NORTH ANNA 3 FSER

Figure 2.4.2-1. Site map with locations of drainage basins and primary hydraulic features of the drainage system flooding analysis from local intense precipitation (after North Anna 3 COL FSAR Figure 2.4-201)

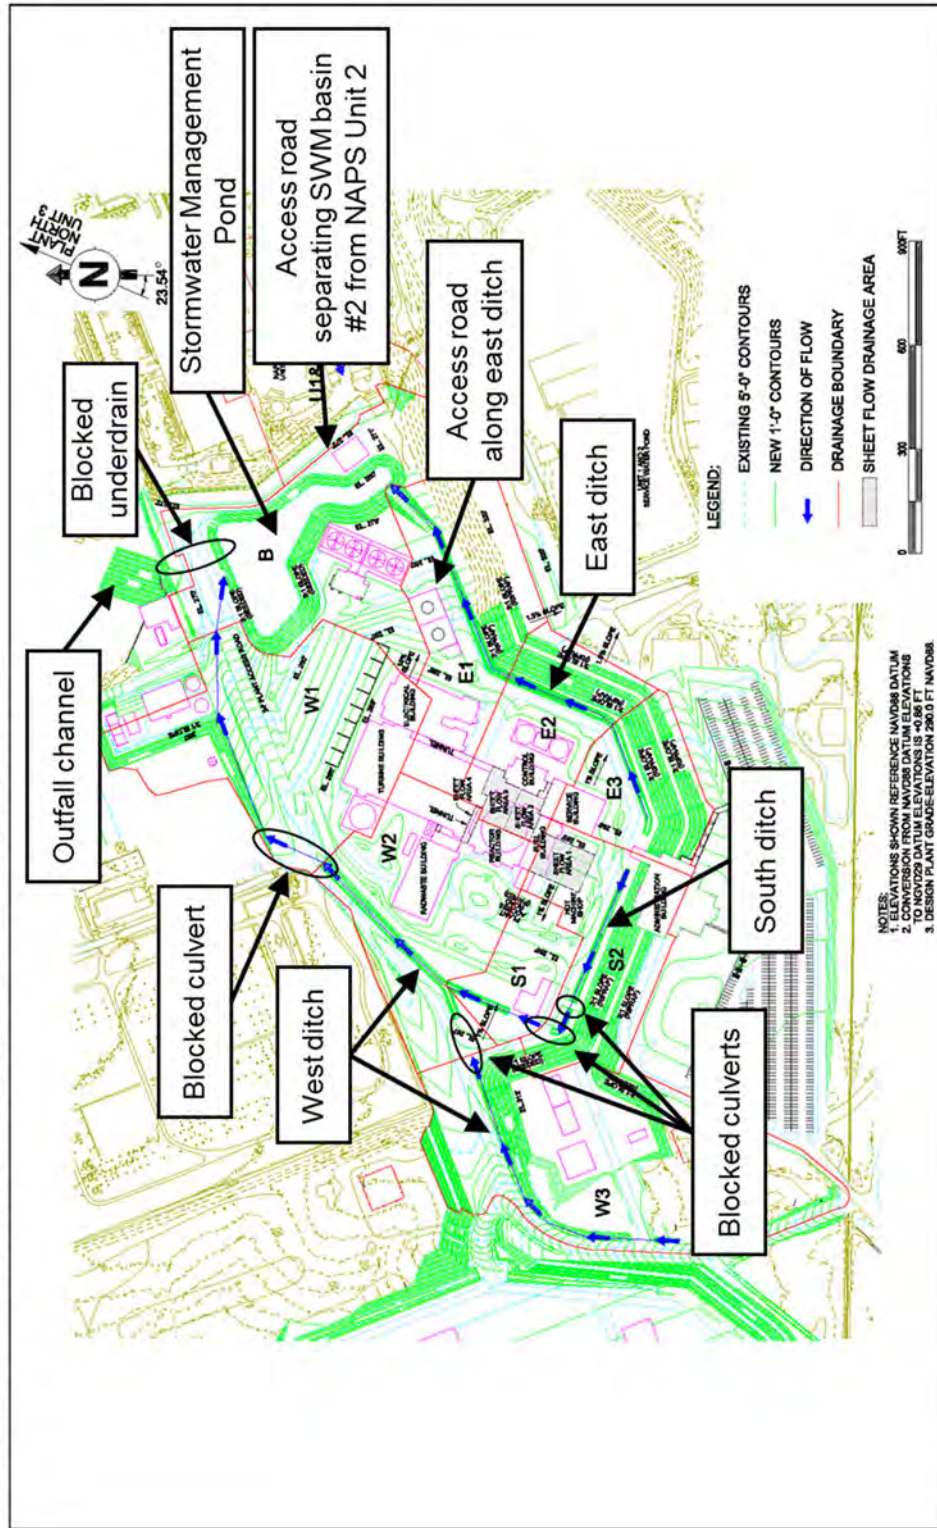
The site drainage plan consists of three drainage channels (labeled east ditch, south ditch, and west ditch in Figure 2.4.2-1), a stormwater management pond, and an outfall channel. Figure 2.4.2-1 also shows the layout of drainage basins used in the estimation of local intense

A drainage divide is located between the North Anna 3 stormwater management pond and the existing Unit 2 site at an elevation of 82.91 m (272.0 ft) NAVD88. As indicated in Figure 2.4.2-1, the stormwater management pond received flow from the east and west ditches. Discharge was routed from the stormwater management pond by overtopping the main access road, which was simulated in the HEC-RAS model as a broad-crested weir. The maximum water surface elevation computed by the COL applicant in the stormwater management pond was 82.84 m (271.8 ft) NAVD88 resulting in a freeboard of 0.06 m (0.2 ft). The COL applicant concluded that flows in North Anna 3 site would not affect the existing Units 1 and 2. Although the staff found references to Subbasin U1&2 in North Anna 3 COL FSAR Tables 2.4-201 and 2.4-202 (Table 2.4.2-2), the COL applicant did not adequately explain how Subbasin U1&2 derived flow from the existing Units 1 and 2 area. In RAI 02.04.02-10, the staff requested that the COL applicant provide additional details regarding how the rational method was applied to estimate peak discharges, particularly from Subbasin U1&2 (ML14345B075). The COL applicant's response dated January 19, 2015 (ADAMS Accession No. ML15022A199), and the staff's evaluation are described in the staff's technical evaluation section below in this SER.

The staff independently computed the times of concentration using Figure 2.4.2-1 for areas, distances, and slopes, and by using WinTR-55 software (SCS 1986, NRCS 2009). The TR-55 methodology includes three types of flow: overland (sheet) flow, concentrated flow, and channel flow. For sheet flow, the staff used Manning's roughness coefficients as provided in NRCS (2003). As indicated in the North Anna 3 COL FSAR, there are two land cover types: graveled areas and grass covered areas. For sheet flow over graveled areas, NRCS (2003) recommends a Manning's roughness of 0.02, while for sheet flow through dense-grass coverage a value of 0.24 is recommended. The WinTR-55 software provides drop-down lists for selection of surface type (as described by Manning's roughness values). For sheet flow, a 0.02 value for graveled areas is not provided in WinTR-55, so the staff used the next largest available value of 0.05. The staff assumed a 1 percent surface slope as indicated in Figure 2.4.2-1, though the staff expects that between buildings surface slopes would be smaller. Estimating the distance that sheet flow will occur is problematic without detailed information. The staff used a distance of 30.48 m (100 ft), which is the maximum distance that sheet flow could occur according to NRCS (2003). Comparing the staff-computed values with those provided by the applicant showed that for the east drainage areas the times of concentration are similar, though the staff's estimates are short by 1 to 2 minutes. However, the staff-computed times of concentration for the west and south drainage areas are shorter than those computed by the COL applicant, for example 10.4 min versus 20.4 min. Examination of additional information pertaining to the COL applicant's computation of times of concentration indicates the COL applicant used higher Manning's roughness coefficients for sheet flow and smaller slopes than used by the staff. The staff noted that in Subbasin S2, the applicant's estimated time of concentration for sheet flow accounts for over 60 percent of the subbasin's response time. Consequently, the COL applicant's basis for estimating sheet flow was needed.

Figure 2.4.2-2. Site map with locations of the inline control structures that correspond to blocked culverts (after North Anna 3 COL FSAR Figure 2.4-203)

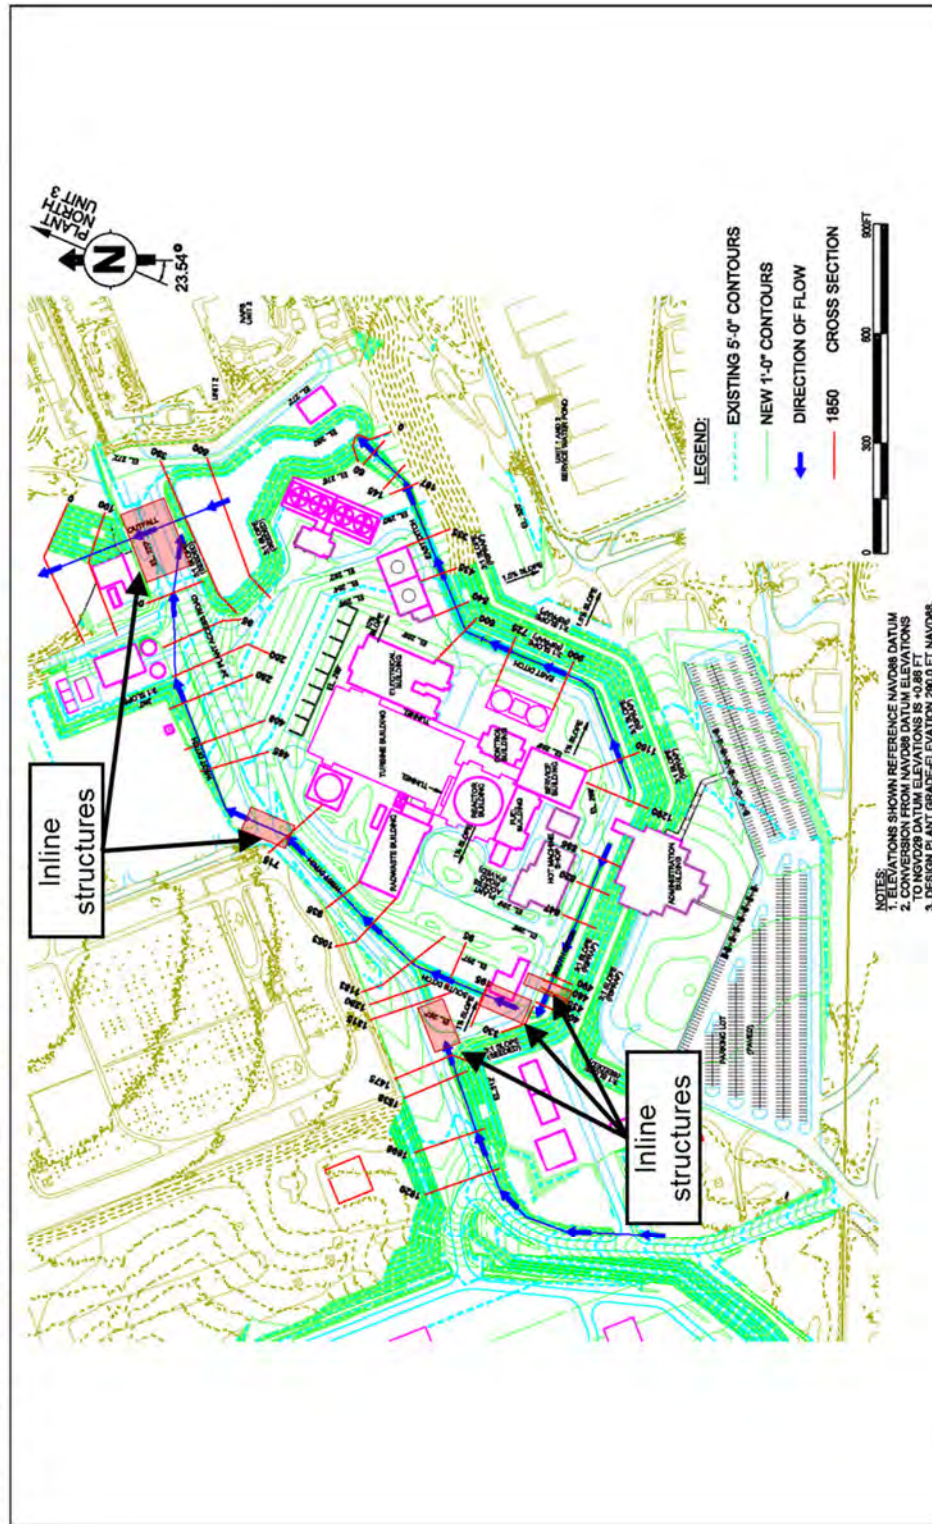
The COL applicant assumed that the roads crossing the west and south ditches and the outfall from the stormwater management pond were completely blocked and functioned as weirs during the flooding from local intense precipitation (Figures 2.4.2-1 and 2.4.2-2). As found in the COL applicant's HEC-RAS input files, inline weirs were designated as broad-crested weirs with discharge coefficients specified as either 2.6 or 2.4. Because the COL applicant did not provide a justification for choosing the lower of these two discharge coefficient values, in RAI 02.04.02-14, the staff requested that the COL applicant provide a discussion of the basis for selecting weir discharge coefficients. The COL applicant's response dated January 19, 2015 (ADAMS Accession No. ML15022A199), and the staff's evaluation are described in the staff's technical evaluation section below in this SER.

The staff noted that the applicant's HEC-RAS input file geometry was inconsistent with the connectivity of the west ditch for the storm water management pond. In RAI 02.04.02-12, the staff requested that the COL applicant explain the apparent disagreement between the HEC-RAS input files and North Anna 3 COL FSAR Figures 2.4.201 and 2.4.203 which illustrate the connection of the west ditch to the stormwater management pond. In response to RAI 02.04.02-12 (ADAMS Accession No. ML15022A199), the COL applicant stated that as the west ditch approaches the stormwater management pond, water will flow in three directions: a portion will flow north into an area adjacent to the intake channel, another portion will flow south into the stormwater management pond, and a third portion will continue flowing along the west ditch towards the stormwater management pond outlet and into Lake Anna. The COL applicant chose to direct all flow from the west ditch into the stormwater management pond because the calculated water surface elevation would then be conservatively higher in Subbasin B. The COL applicant proposed updating North Anna 3 COL FSAR Figures 2.4-201 and 2.4-203 to correctly depict the discharge from the west ditch into the stormwater management pond, consistent with the HEC-RAS model setup. The staff determined that the COL applicant's response was adequate and verified that the appropriate updates to Figures 2.4-201 and 2.4-203 are incorporated into the FSAR, Revision 9, and, therefore, Confirmatory Item 2.4.2-3 from the staff's advanced SER for North Anna 3 is resolved and closed.

In response to staff's RAI 02.04.02-10 through 02.04.02-15, the COL applicant proposed updating the North Anna 3 COL FSAR in a future revision (ADAMS Accession Nos. ML15022A199 and ML16229A451). The staff verified that the appropriate updates are incorporated into the FSAR, Revision 9, and, therefore Confirmatory Items 2.4.2-1 to 2.4.2-6 from the staff's advanced SER for North Anna 3 are resolved and closed.

Figure 2.4.2-3. Site map with locations of supercritical flow and of hydraulic jumps from the applicant's HEC-RAS model and North Anna 3 COL FSAR Figure 2.4-221 (after North Anna 3 COL FSAR Figure 2.4-203)

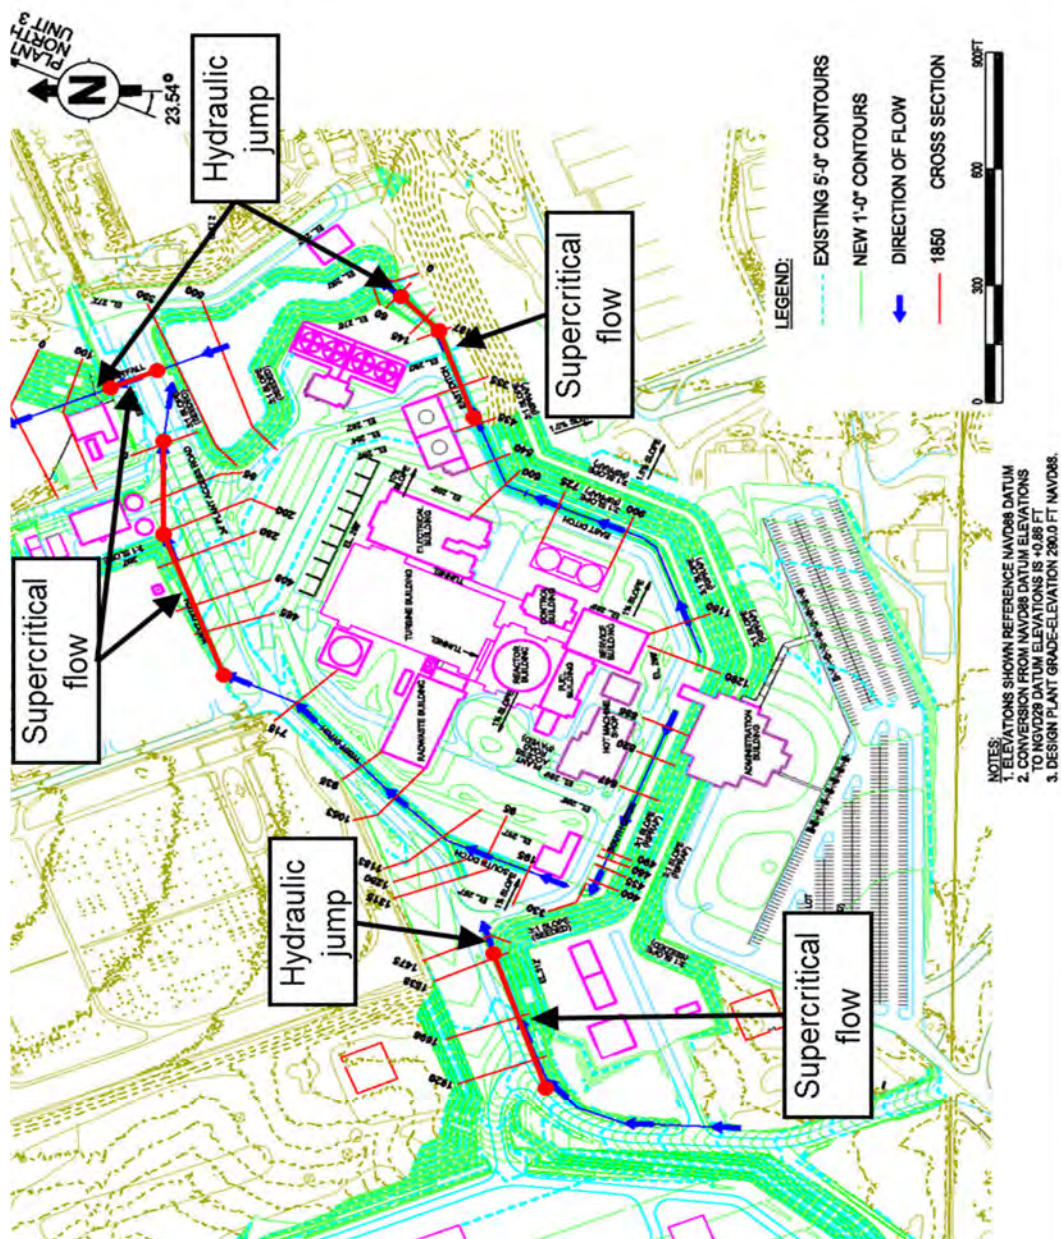
Based on the staff's examination of the COL applicant's HEC-RAS analysis results, supercritical flow was found to occur in the east and west ditches during flooding from local intense precipitation. In these locations, the water velocities ranged from 2.1 m/s (7.0 fps) to 4.5 m/s (14.7 fps) with Figure 2.4.2-3 showing the locations of supercritical flow based on the HEC-RAS analysis. In North Anna 3 COL FSAR Section 2.4.2.3, the COL applicant stated that:

Figure 2.4.122-1. NAPS Unit 3 groundwater head observations on 5/30/2007 as a function of ground surface elevation at the well

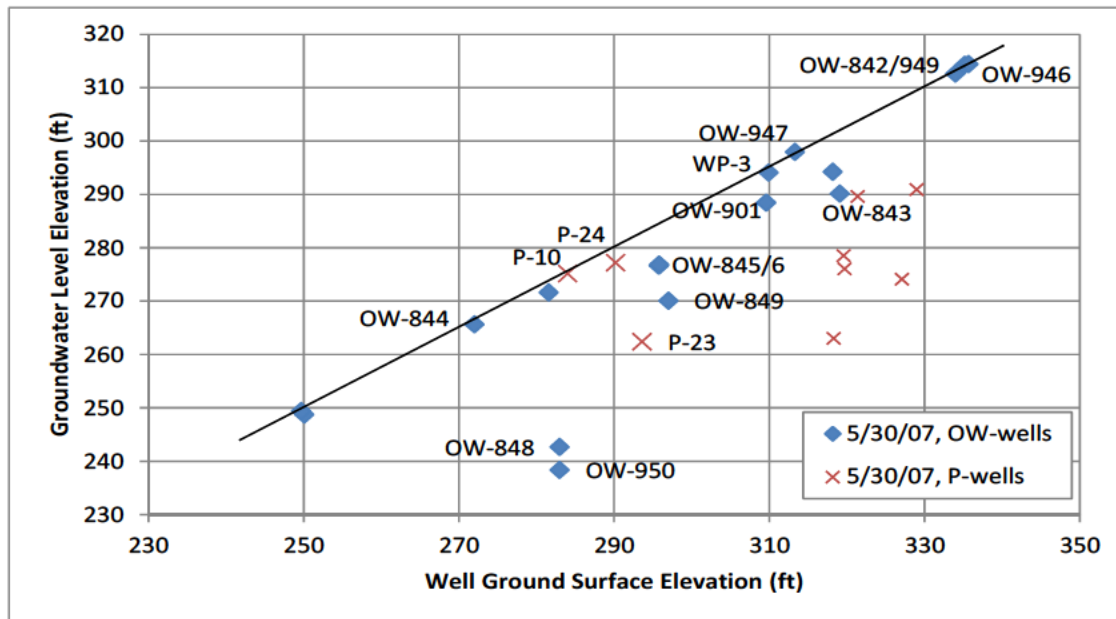
While no observations fall significantly above the envelope line in Figure 2.4.12-1, a number of observations fall significantly below the line. The staff examined the current site topography, as shown on FSAR Figure 2.4-206, and determined that the wells with observations below the line in Figure 2.4.12-1 tended to be located above and near a significant topographic slope. For example, OW-848 and OW-950 are on the bluff above the proposed North Anna 3 intake bay, and OW-849 and OW-843 are above the cut-slope for the switch yard. In contrast, the observations that lie close to the line in Figure 2.4.12-1 tended to be in areas of relatively flat topography, or near the bottom of topographic slopes. For example, OW-844 lies just below the cut-slope down to the Unit 1/2 operations level.

The COL applicant's pre-construction model, calibrated using the May 30, 2007 groundwater observations, resulted in groundwater heads at several observation wells that were above the envelope line shown in Figure 2.4.12-1. The greatest deviations were at wells OW-945, a relatively low-lying area where the model produced flooded conditions, and OW-844, located at the bottom of a cut-slope. The deviation at OW-844 was about 1.22 m (4 ft). Based on the observations shown in Figure 2.4.12-1, the staff concluded that groundwater head measured in a well located at a surface elevation of 88.39 m (290 ft) (the North Anna 3 design plant grade) would be unlikely to exceed 85.34 m (280 ft). The COL applicant's post-construction model predicted heads about 1.22 m (4 ft) greater than this in the power block area: 86.53 m (283.9 ft) at the Ancillary Diesel Building, located near the cut-slope down to the power block. The staff concluded that the COL applicant's groundwater model will tend to over-estimate groundwater heads below a cut-slope such as that planned around the North Anna 3 power block area.

Figure 2.5.1-5. LiDAR-Derived Relief Map of the 2011 Mineral, VA, Earthquake Vicinity (from FSAR Figure 2.5.1-212A, Rev 9). Relief is represented as elevation difference within 0.5 km. The margin of Ellisville Biotite Granodiorite based on Burton et al. (2014) and Dicken et al. (2005)

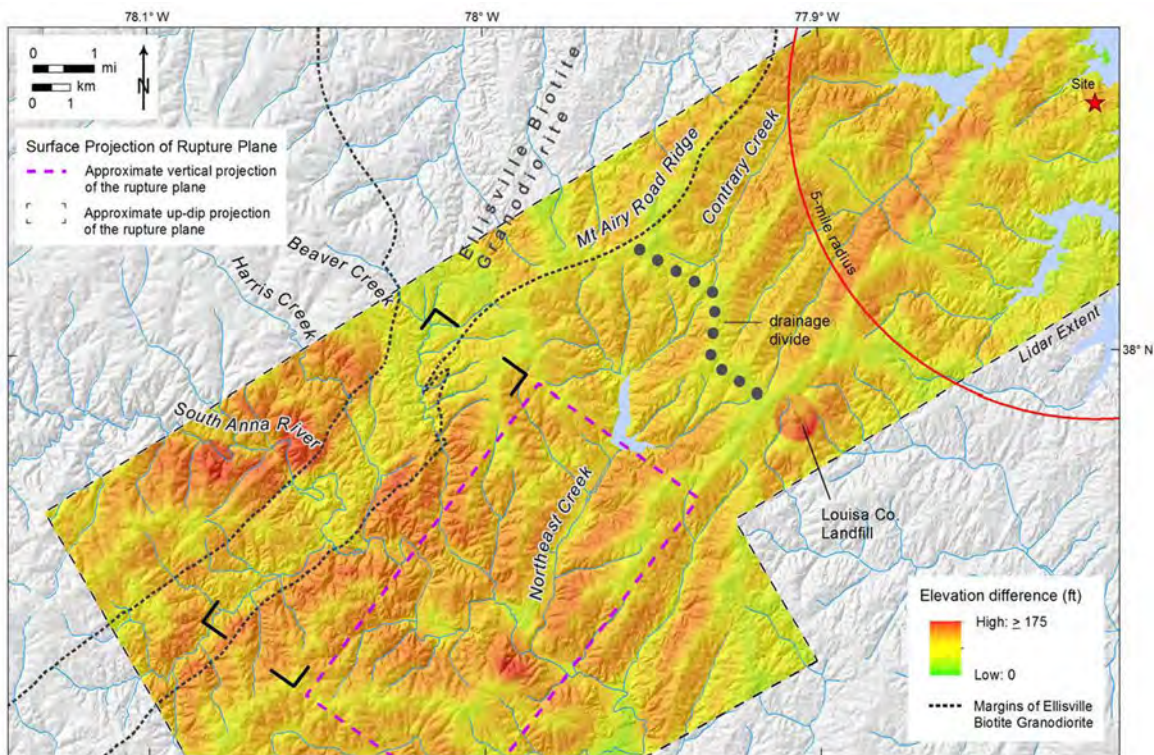
In response, the COL applicant provided new map figures to provide a basis for their analysis regarding surface deformation related to the Mineral earthquake. Figure 2.5.1-5 shows a newly derived relief map using a linear color ramp to symbolize the local relief value across the epicentral area and to the NE, closer to North Anna 3. The staff notes that, in the area around the Ellisville pluton neck, high to low relief boundaries closely correspond to geologic map unit contacts. This supports the COL applicant's suggestion that the steep relief gradients are related to lithologic difference between map units rather than subtle tectonic uplift related to shallow earthquakes. The Chopawamsic Formation, to the NW and SE of the Ellisville pluton neck, is more erosion resistant than the Ellisville and, therefore, supports higher elevation and higher relief zones. In addition, staff notes, that the South Anna river system crosses the same geologic contacts by the Ellisville neck and the Mineral earthquake epicentral area. The river is a significant erosional agent in the area and lowers elevations in its basin but also contributes to the development of high local relief within its basin (Compare Figures 2.5.1-5 and 2.5.1-6). The staff also notes that high relief values diminish to the NE, near the basin divide between the South Anna and the North Anna river systems. The most continuous areas of low relief can be found along prominent drainage divides and areas of higher elevation, which represent areas farthest removed from the increased erosion rates associated with trunk streams. The staff

The COL applicant stated that the FSAR would be updated to reflect aspects of this response. The staff finds the proposed COL FSAR changes acceptable and verified that the appropriate changes are incorporated into the FSAR, Revision 9, and, therefore, Confirmatory Item 2.5-04 from the staff's advanced SER for North Anna 3 is resolved and closed.

Figure 2.5.1-4. NAPS Geologic Field Reconnaissance after the 2011 Mineral, VA, earthquake showing traverse routes, waypoints and the LiDAR survey boundary (from FSAR Figure 2.5.1-204, Rev. 9)

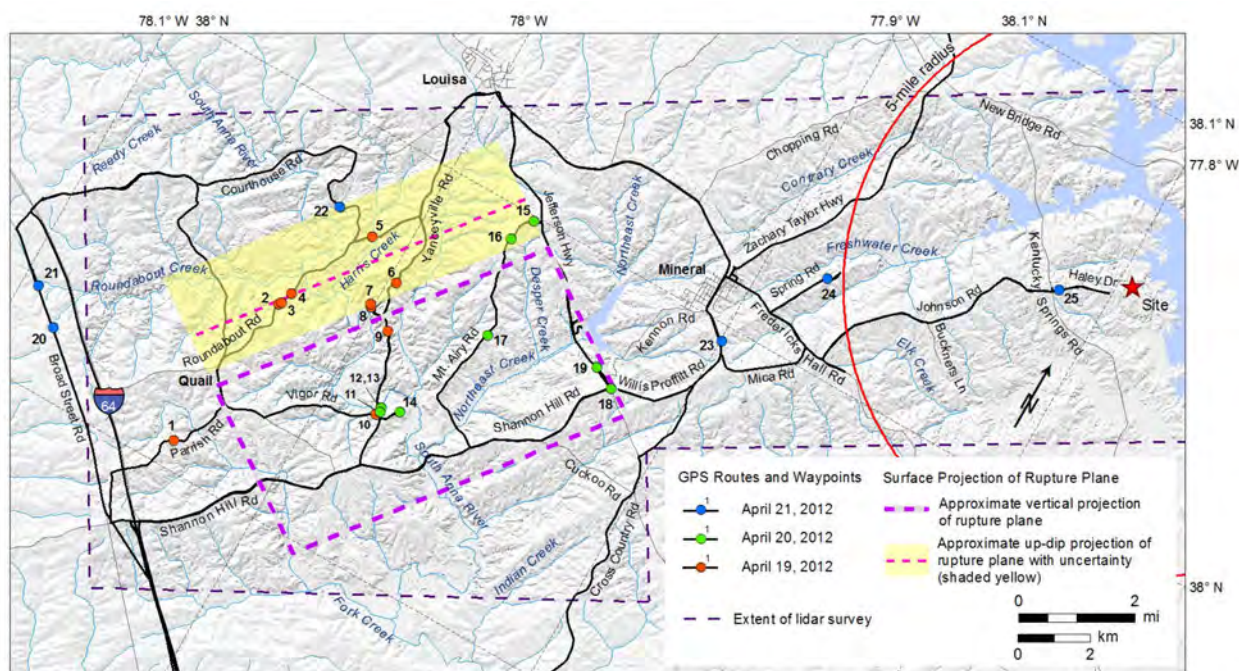
- a) At each waypoint, what was examined and what is its significance.
- b) Provide a high resolution LiDAR map (scale ~1:10,000) for areas immediately west of North Anna 3 where fault 'a' might be located, such as waypoint sites 23, 24, and 25.
- c) Discuss longitudinal stream profile analysis completed in the epicentral area. Discuss any anomalies revealed by this analysis that could indicate subtle tectonic deformation in the hanging wall of the Quail fault, such as gradient changes, offset stream terraces, elevated topography.
- d) Explain how you evaluated the Quaternary geology of the epicentral area and the distribution, correlation and elevation of river terraces on the South Anna River. Discuss any indication of subtle surface uplift in river terraces on the hanging wall of Quail fault that might indicate prolonged or repeated surface deformation.

In a June 10, 2014, response to RAI 02.05.01-5a and b (ADAMS Accession No. ML14177A441), the COL applicant provided a table with details for the significance of each waypoint visited during the field reconnaissance program. Observations at some of the waypoints confirm

Figure 2.5.1-8. Stream Profiles with Geology of Burton et al. (2014) from FSAR Figure 2.5.1-217 and -219, Rev. 9

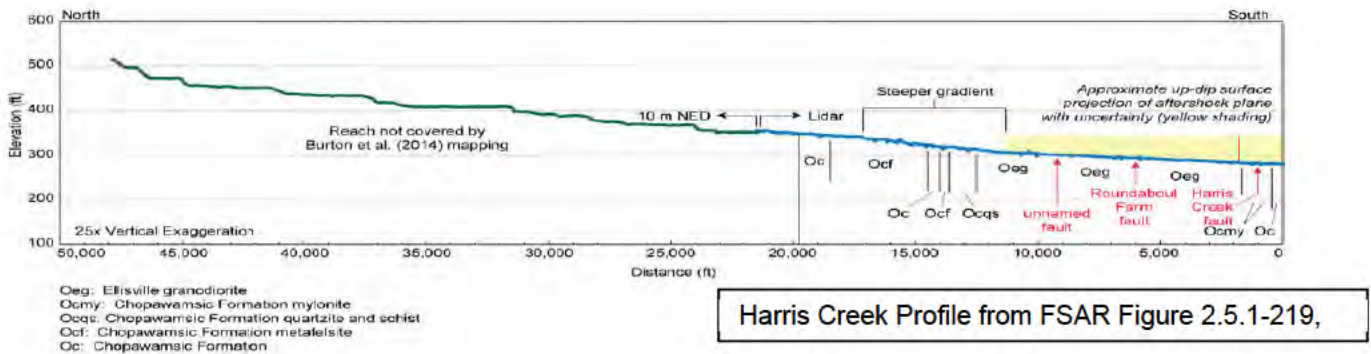
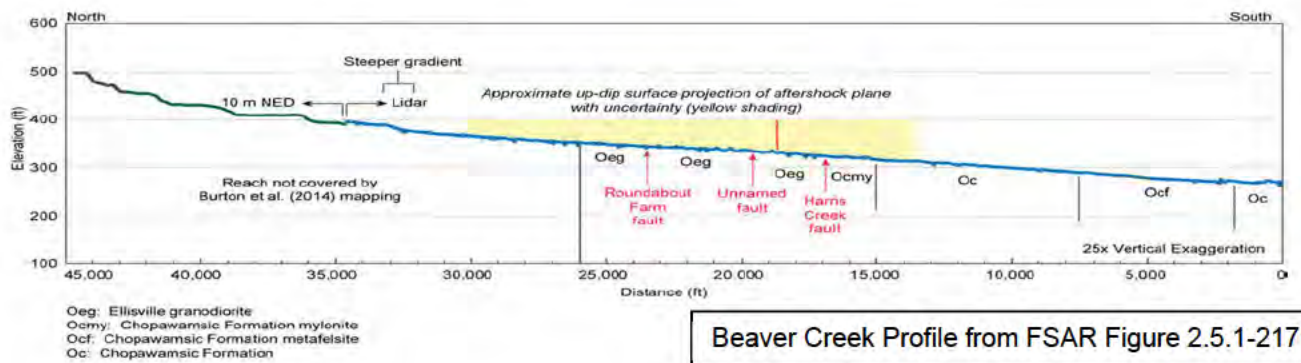
In a September 30, 2014, response to RAI 02.05.01-8c (ADAMS Accession No. ML14274A303), the COL applicant stated that a subtle gradient change lies near a 20 percent increase in drainage area due to confluences of Roundabout and Harris Creeks, and upstream of a 17 percent increase in drainage area due to confluences of Beaver and Northeast Creeks and provided a new figure for the South Anna River profile with drainage area increases (RAI 02.05.01-8 Figure 11). The staff notes that Dominion considered and performed additional assessments on some profiles, such as stream gradient (SL) index (Hack, 1957), slope versus distance, and drainage basin versus distance (for South Anna River only) but these methods did not provide useful results for evaluating the subtle anomalies due in part to the extremely low gradient of the streams and the high-frequency (HF) data noise (Figure 2.5.1-8).
